GORGES ACRES

RE: SUB 2000-31 -- Final Plat of GORGES ACRES ADDITION

RE: SUB 2000-31 -- Final Plat of GORGES ACRES ADDITION

CASE NUMBER: SUB 2000-31-- GORGES ACRES

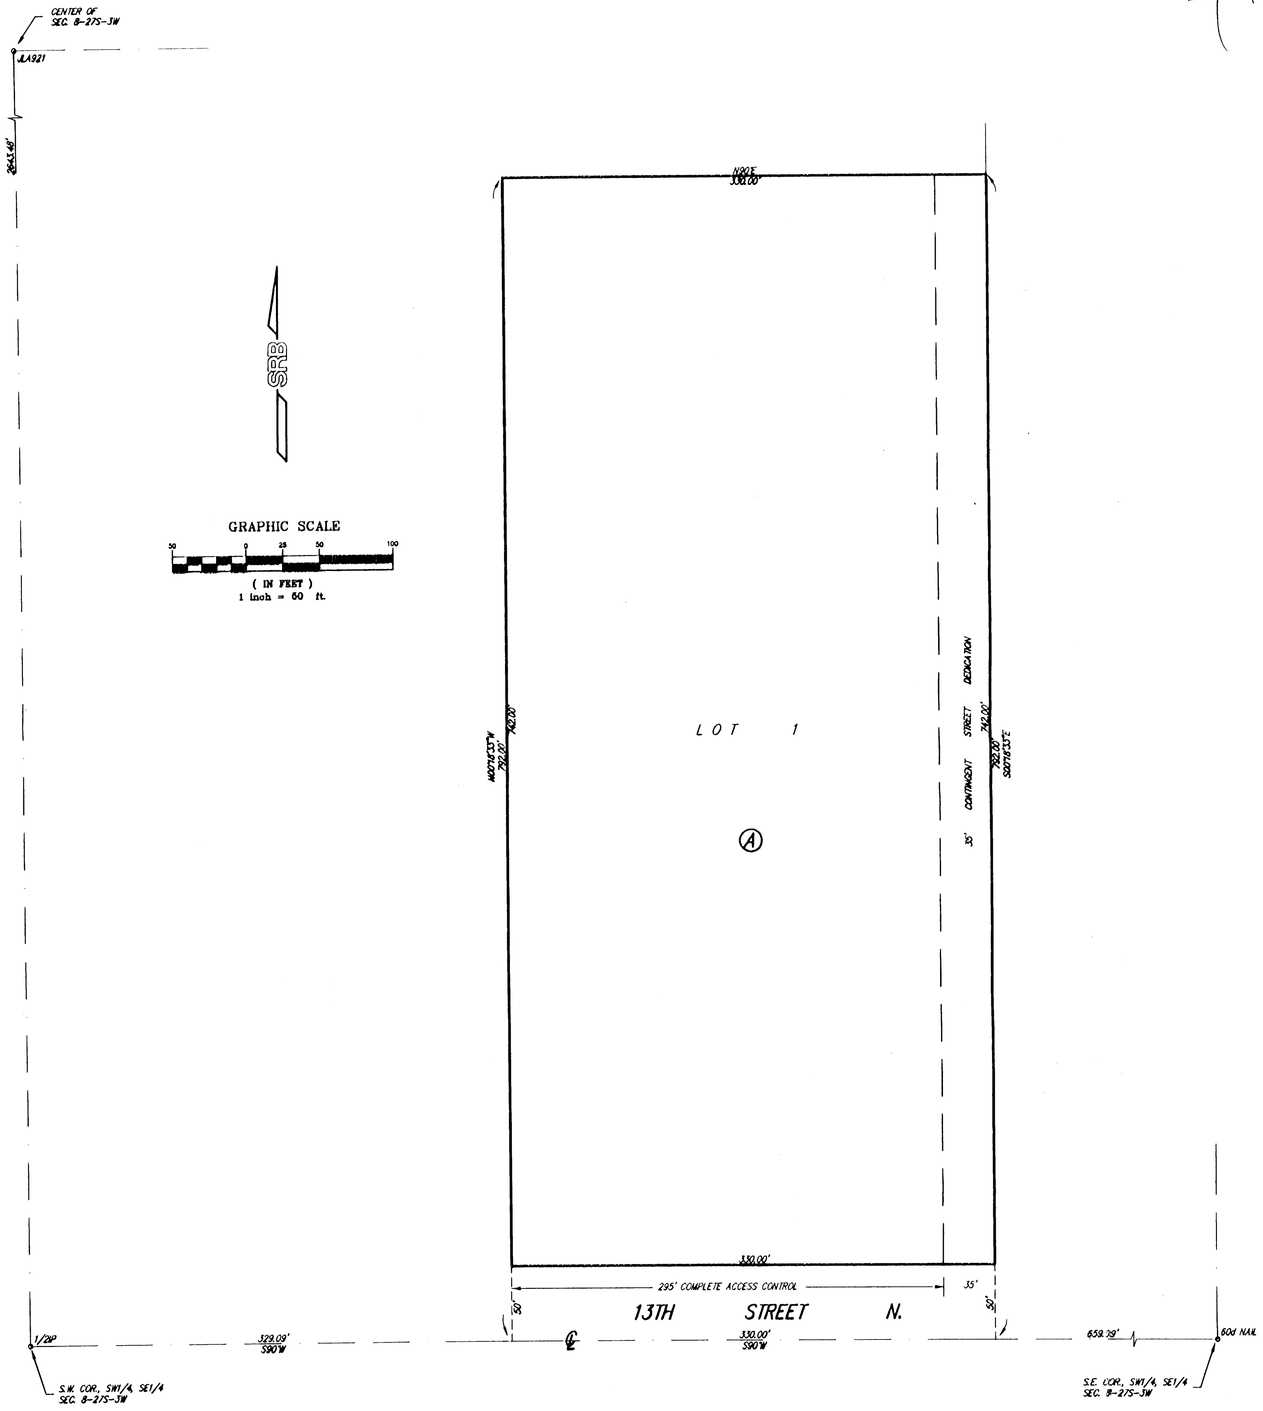
A. Since neither municipal water nor sanitary sewer is available to serve this property, the applicant shall contact the Environmental Health Division of the Health Department to find out what tests may be necessary and what standards are to be met for approval of on-site sewerage facilities and water wells. A memorandum shall be obtained specifying approval. ***Standard soil testing is required.***

C. County Engineering needs to comment on the status of the applicant's drainage plan. ***A Floodway Reserve is required within the northern third of the plat to handle off-site drainage.*** not without permission e-mail 6-16-00

D. The applicant shall dedicate a 35-ft half street contingent right-of-way along the east or west line of the plat to improve access to future development to the north.

E. County Engineering needs to comment on the need for access controls. The final plat shall reference the access controls in the plattor's text. ***County Engineering requires access control except for one opening. MAPD recommends that the opening coincide with the location of the contingent right-of-way dedication.***

F. If platted, the building setback needs to be 35 ft to conform with the Zoning Regulations for section line roads.

I. The plattor's text shall include language that a drainage plan has been developed for the plat and that all drainage easements, rights-of-way, or reserves shall remain at established grades or as modified with the approval of the applicable City or County Engineer, and unobstructed to allow for the conveyance of stormwater.

K. The applicant's engineer is advised that the Register of Deeds is requiring the name(s) of the notary public, who acknowledges the signatures on this plat, to be printed beneath the notary's signature.
